PHP - Technical Bulletin

Bulletin Number: TB-240201

Subject: P25AG One-Way Fuel Check Valve

Scope: P25AG, 2kw Gas Heater

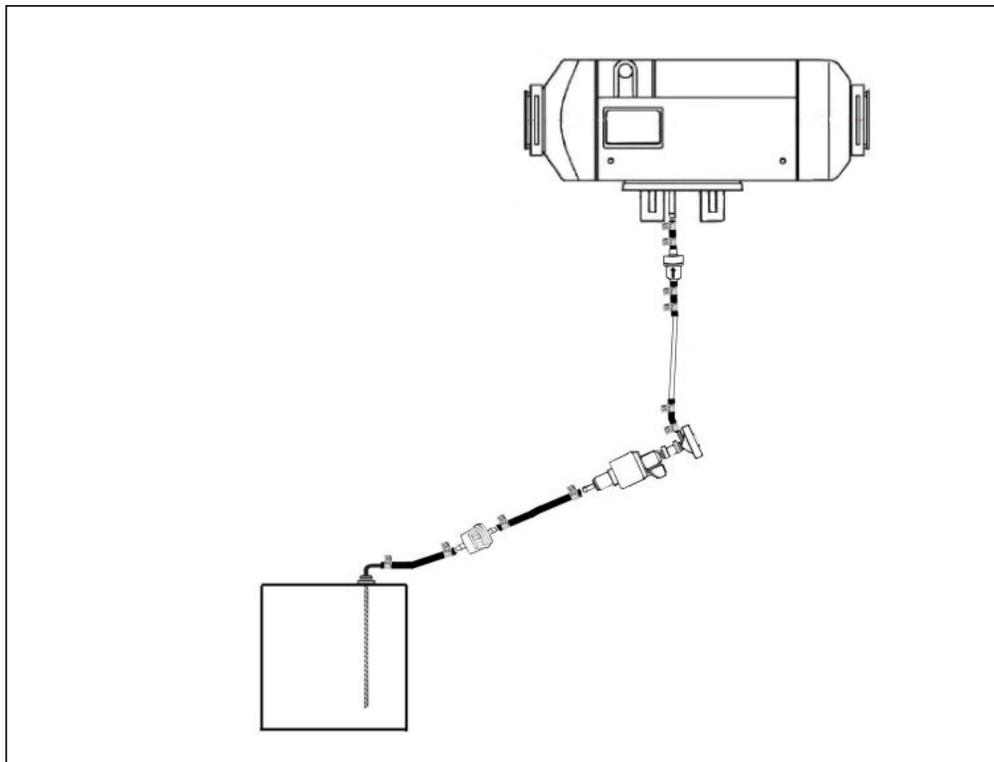
The original manual did not show the One-Way Check Valve required for the fuel system.

It is necessary to install this to ensure the fuel system will operate properly.

Failure to install this may cause starting problems and or inconsistent combustion.

Connect One-Way Check Valve in fuel system between fuel pump and heater as shown.

Arrow on Check Valve should be pointed in direction of fuel flow (towards heater).
